Item Name: Crosstube Assembly, Mid Fwd

DART AEROSPACE LTD		Work Order: 105701
Description: Crosstube Assembly, Mid Fwd		Part Number: D206-667-147TRN
Inspection Dwg: D206-667-147 Rev: A		Page 1 of 2

DRAWING NO. D206-667-147	TITLE CROSSTUBE ASS'Y (206L MID FWD)	REV. A	DART AEROSPACE LTD ENGINEERING ORDER	D.E.O. NO. D206-667-147-A-1	SHEET NO. SHEET 1 OF 1	SCALE NTS
DRAWN <i>qp</i>	CHECKED <i>ASS</i>	MFG. APPR. <i>EB</i>	APPROVED <i>MD</i>	DE APPR. <i>MD</i>		
DATE 11.07.15	DATE 11.07.20	DATE 11.07.21	DATE 11/07/21	DATE 11.07.21

DRAWING NO. D206-667-147		TITLE CROSSTUBE ASS'Y (206L MID FWD)		REV. A		DART AEROSPACE LTD ENGINEERING ORDER		D.E.O. NO. D206-667-147-A-2		SHEET NO. SHEET 1 OF 1		SCALE NTS	
DRAWN AJS		CHECKED		MFG. APPR.		APPROVED		DE APPR.		DATE 12.08.02		DATE 12.08.02	
DATE 12.08.02		DATE 12.08.02		DATE 12.08.02		DATE 12.08.02		DATE 12.08.02		DATE 12.08.02		DATE 12.08.02

DETAIL P
BONDING STRAP INSTALLATION 2 PL

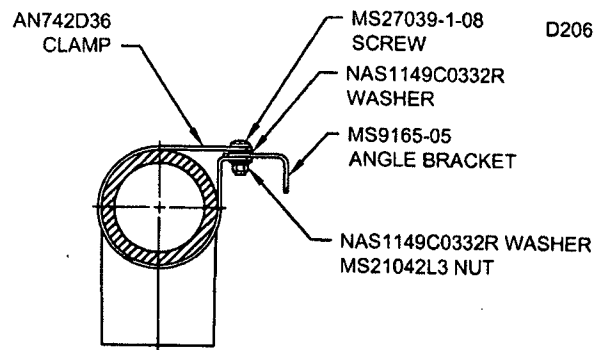
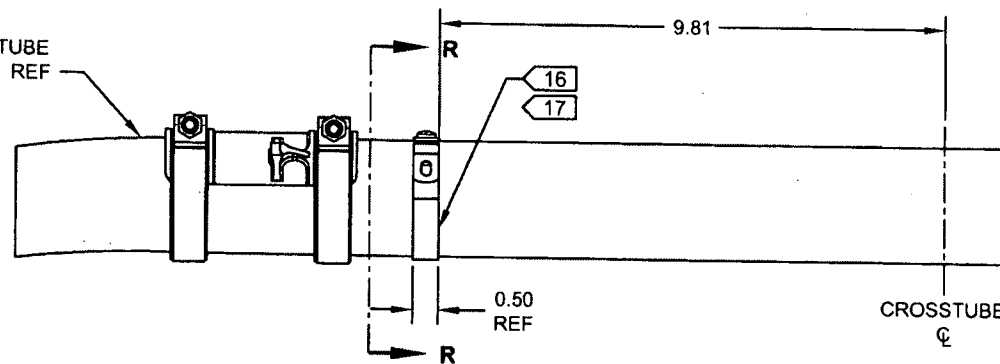
PURPOSE:

ADD ELECTRICAL GROUNDING STRAP

ITEM	QTY -147	PART NUMBER	DESCRIPTION
1	X	D206-667-147	CROSSTUBE ASSEMBLY (206L MID FWD)
⚡			
10	2	AN742D36	CLAMP
11	2	MS9165-05	ANGLE BRACKET
12	2	MS21042L3	NUT (OR MS21042-3)
13	2	MS27039-1-08	SCREW
14	4	NAS1149C0332R	WASHER (OR AN960C10L)

- 16) MASK AREA UNDER CLAMP PRIOR TO PAINTING
- 17) SEAL EDGES WHERE AN742D36 CLAMP MEETS WITH THE CROSSTUBE USING SIKAFLEX-241/-291 OR MIL-S-8802 CLASS B2 OR PROSEAL 890 SEALANT
- 18) PERFORM RESISTANCE CHECK TO ENSURE MAX RESISTANCE IS 10 MILLIOHMS
